Date: 9/13/04

To: T10 Committee (SCSI)

From: George Penokie (IBM/Tivoli)

Subject: SAS UML Corrections

Figure 6 — SAS domain class diagram

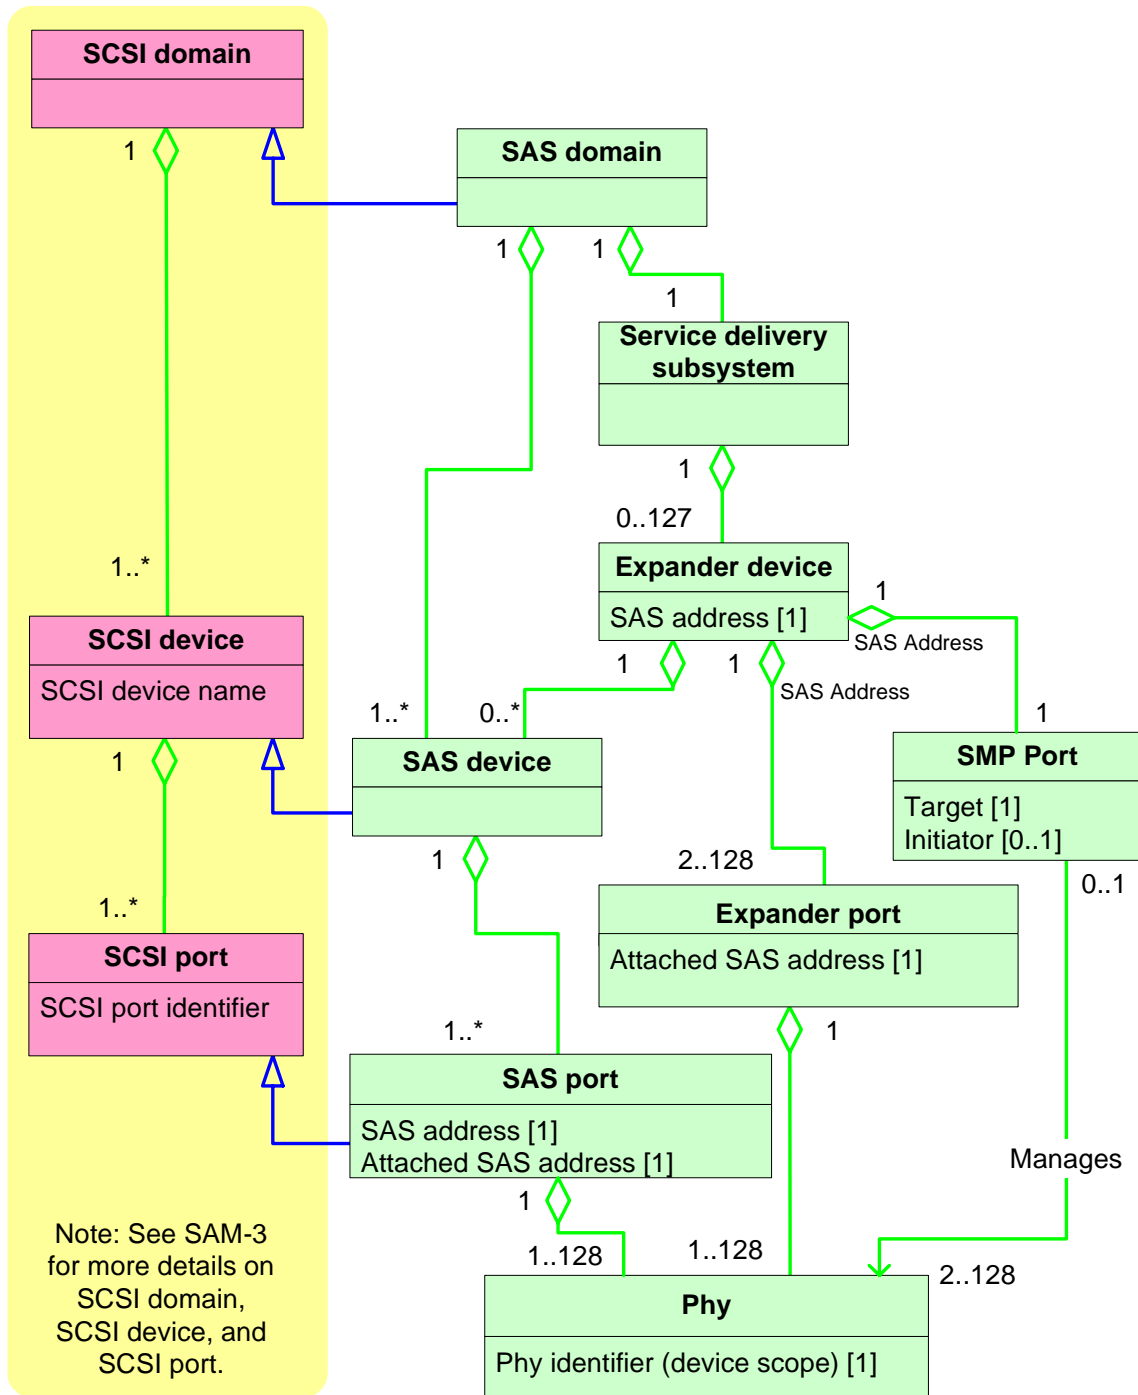
Figure 6 shows the class diagram for a SAS domain, showing the relationships between SAS domain, SCSI domain, service delivery subsystem, expander device, expander port, SAS device, SCSI device, SAS port, SCSI port, and phy classes. Relationships to ATA classes (e.g., ATA domain) are not shown in figure 6.

Figure 7 — Phy classes

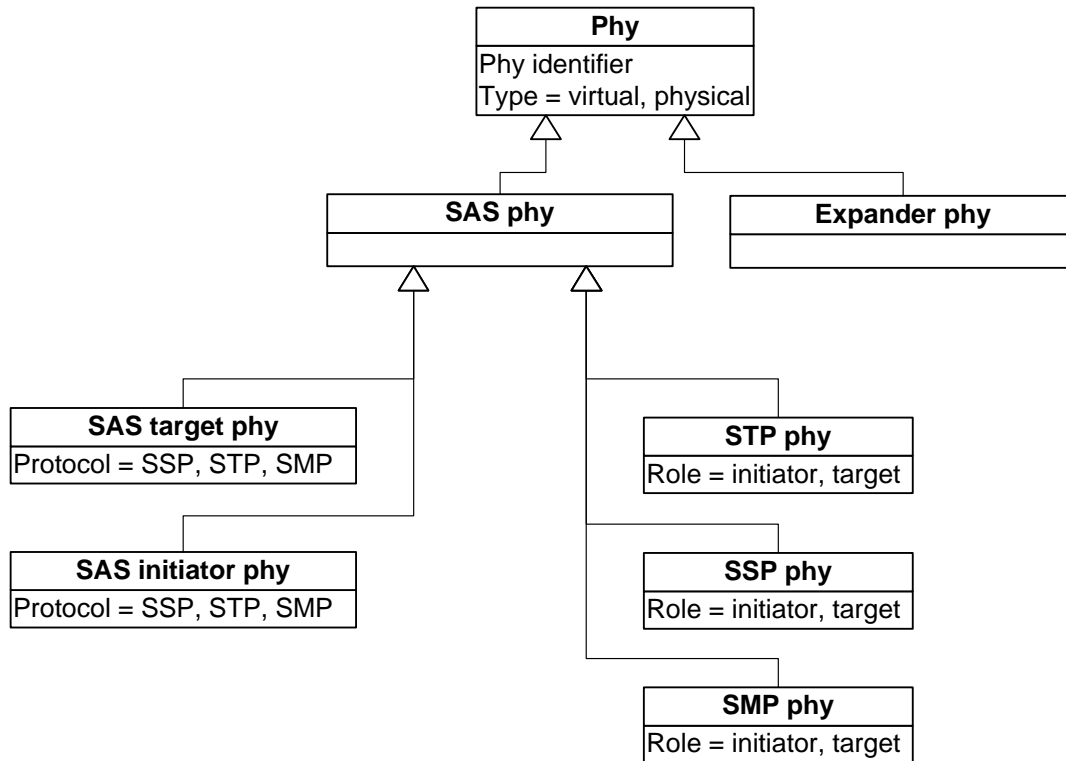
Figure 7 expands the phy class showing the relationships between the following classes:

- a) phy;
- b) SAS phy;
- c) SAS phy;

- d) SAS initiator phy;
- e) SAS target phy;
- f) SSP phy;
- g) STP phy;
- h) SMP phy; and
- i) expander phy.

Figure 9 — Port classes

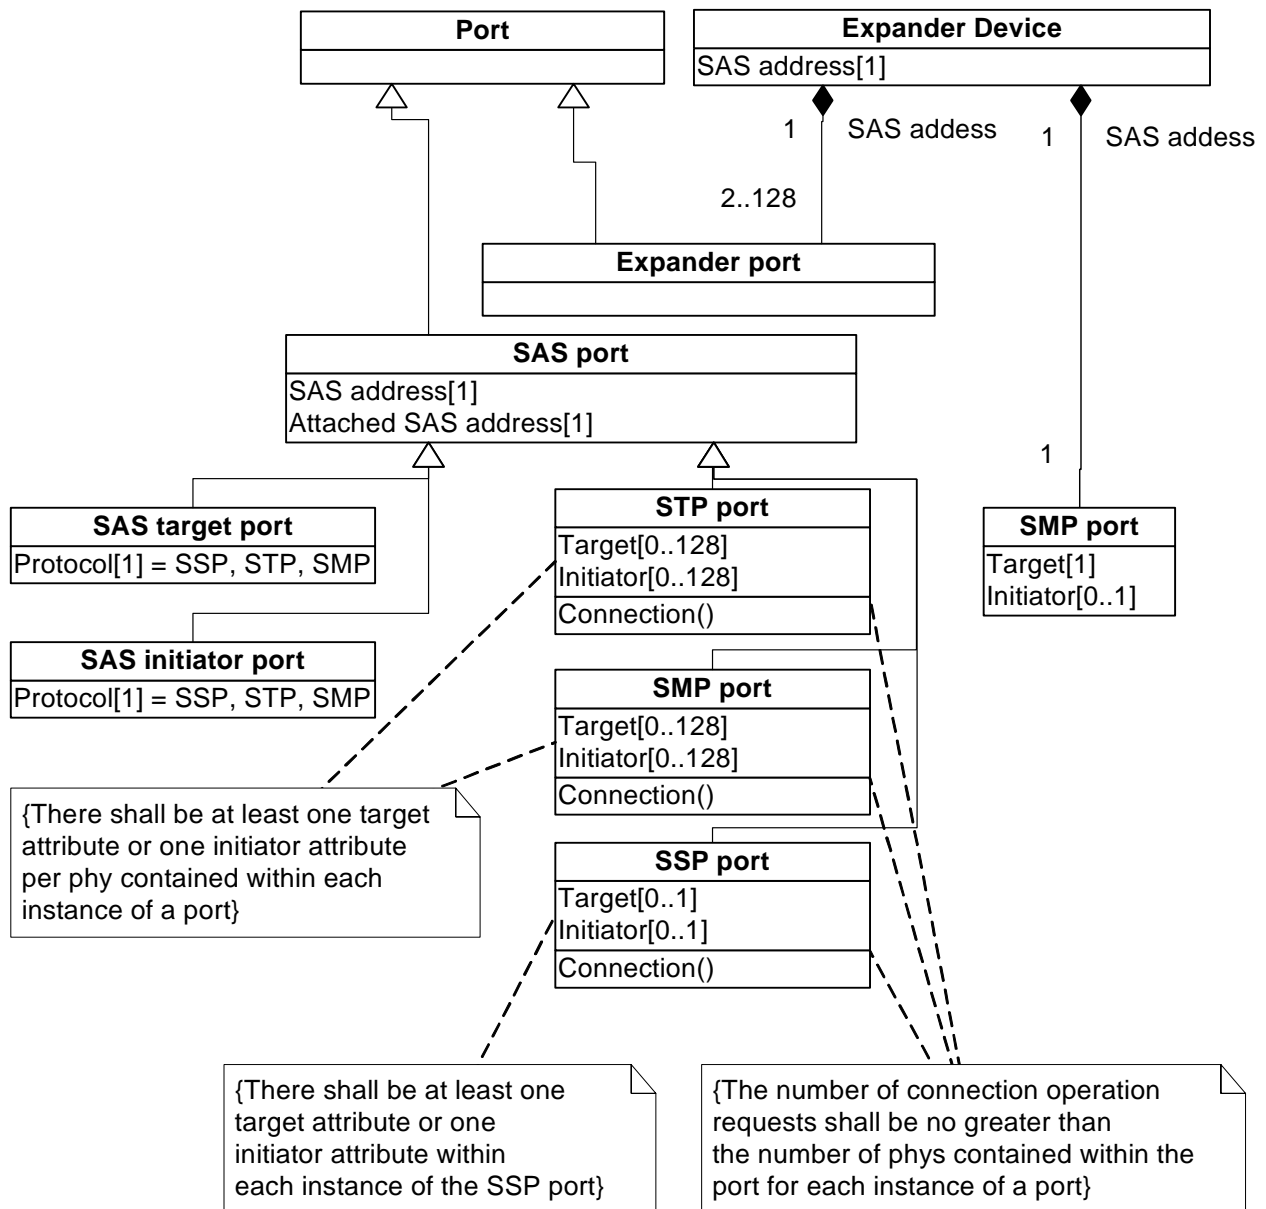
Figure 9 expands the port class and expander class to show the relationships between the following classes:

- a) port;
- b) expander device;
- c) expander port;
- d) SAS port;
- e) SAS target port;
- f) SAS initiator port;
- g) STP port;
- h) SSP port; and
- i) SMP port.

Figure 10 — Port objects

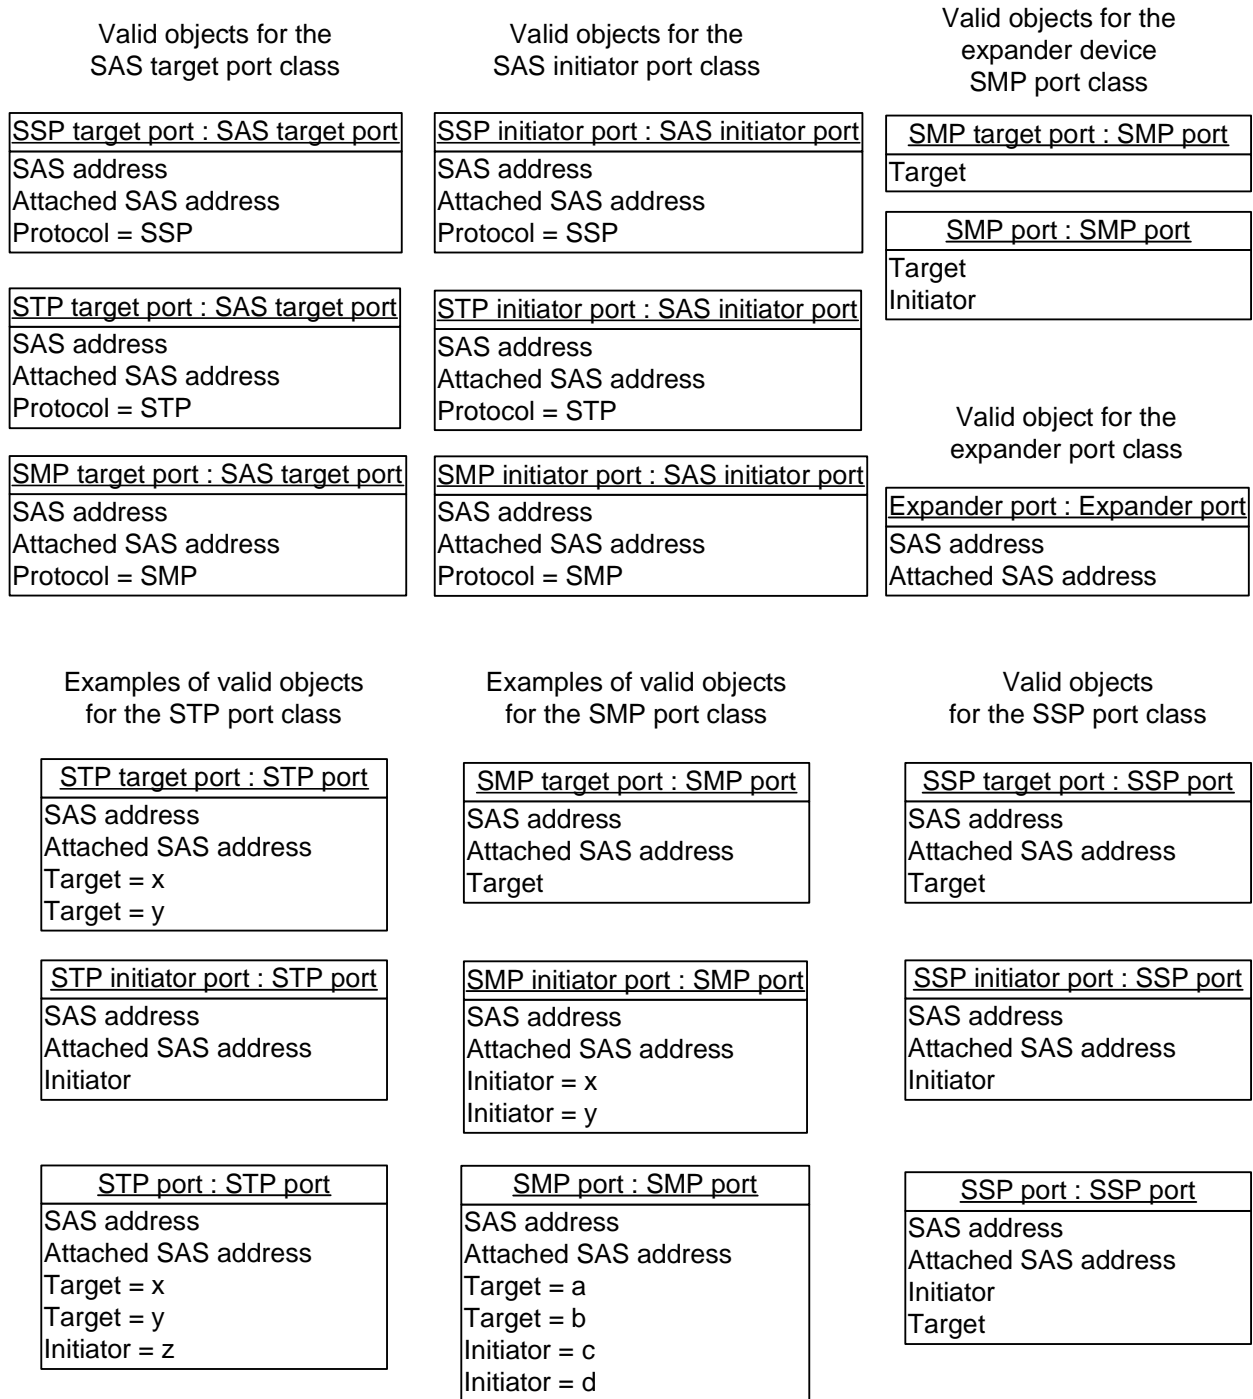
Figure 10 shows the objects that are instances of the:

- a) SAS target port class (i.e., SSP target port, STP target port, SMP target port);

- b) SAS initiator port class (i.e., SSP initiator port, STP initiator port, SMP initiator port);
- c) STP port class (i.e., STP initiator port, STP target port, STP port);
- d) SMP port class (i.e., SMP initiator port, SMP target port, SMP port);
- e) SSP port class (i.e., SSP initiator port, SSP target port, SSP port);
- f) expander device SMP port class (i.e., SMP target port, SMP port); and
- g) expander port class (i.e., expander port).

The objects of the SAS port class are shown in figure 10. A different object may be used on a different connection.

Figure 11 — Expander device classes

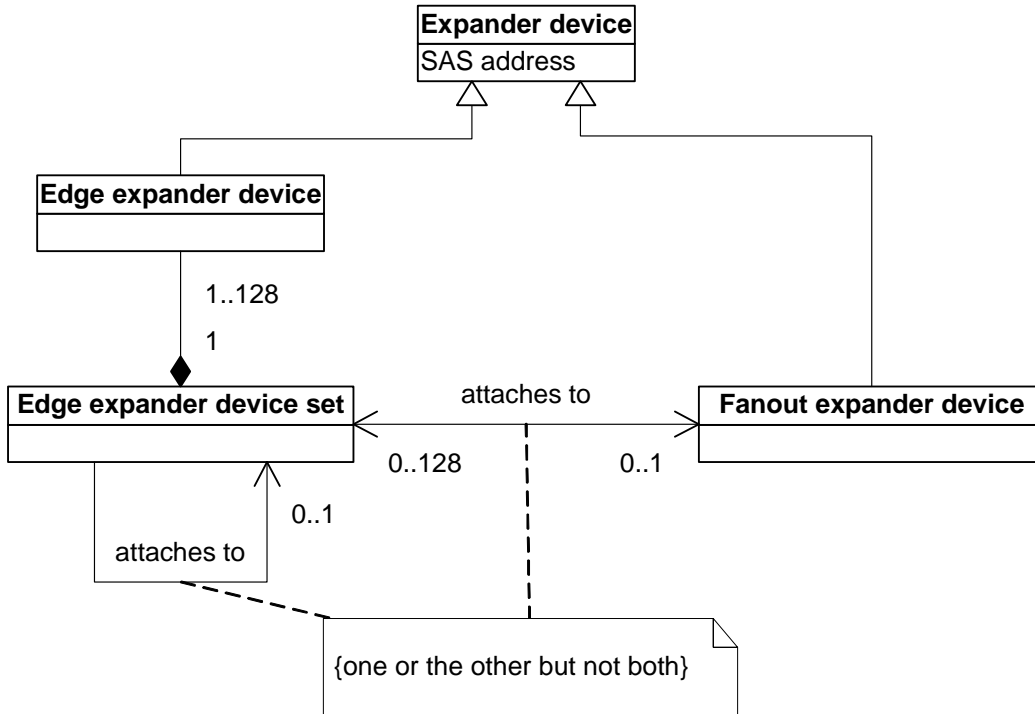
Figure 11 shows the expander device classes.

Figure 12 — State machines for SAS devices

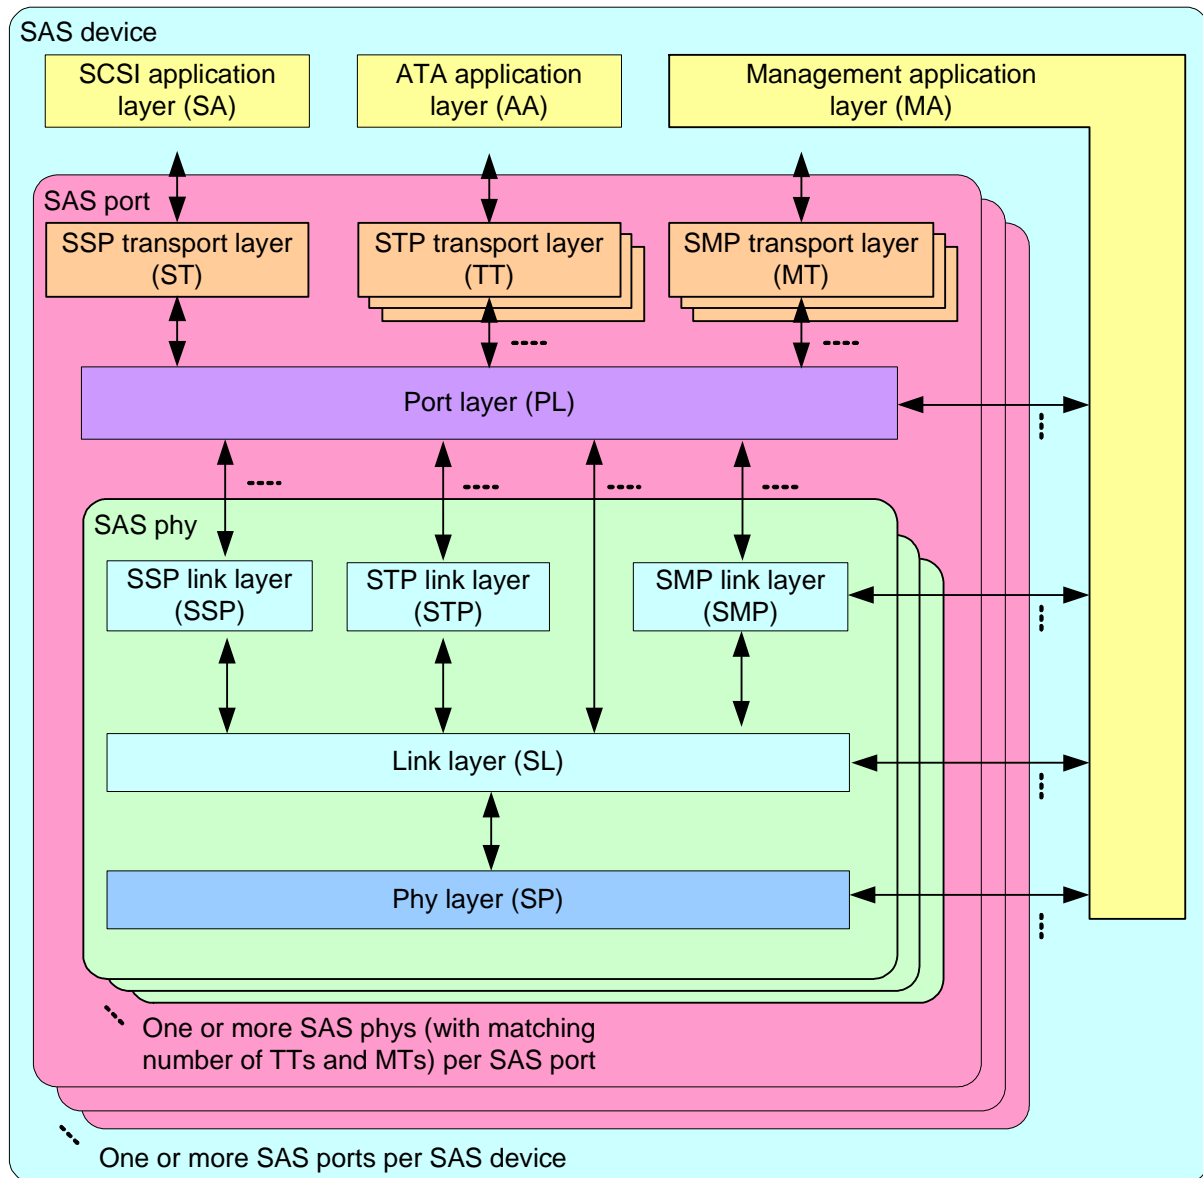
Figure 12 shows the state machines for SAS devices, their relationships to each other and to the SAS device, SAS port, and SAS phy.

Figure 13 — State machines for expander devices

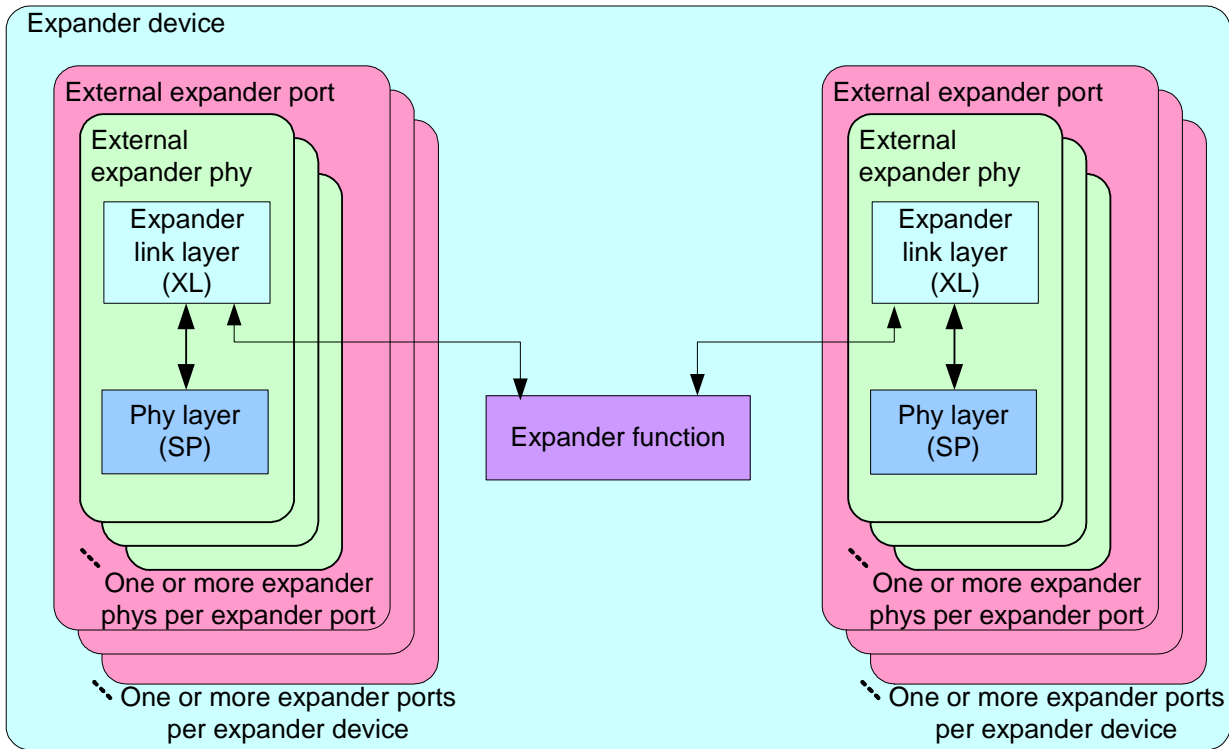
Figure 13 shows the state machines for expander devices, their relationships to each other and to the expander device, expander port, and expander phy. Expander function state machines are not defined in this standard, but the interface to the expander function is defined in 4.6.6.

Figure 14 — State machine and SAS device, SAS port, and SAS phy classes

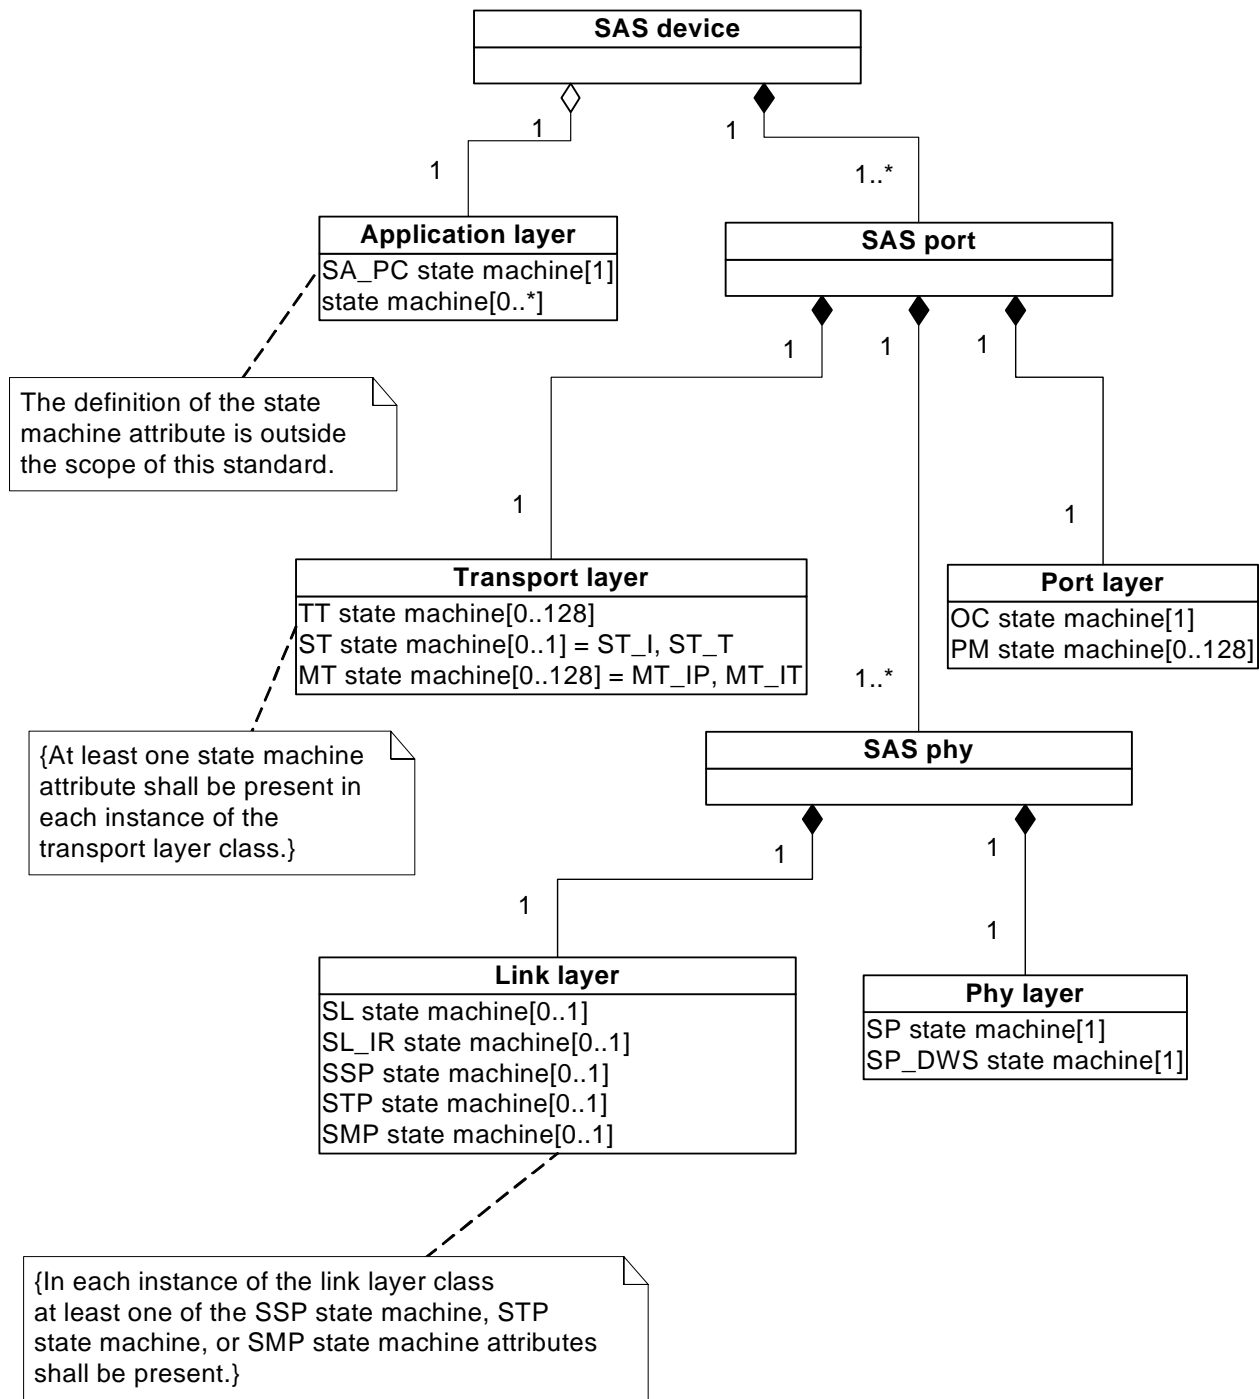
Figure 14 shows which state machines are contained within the SAS device, SAS port, and SAS phy classes.
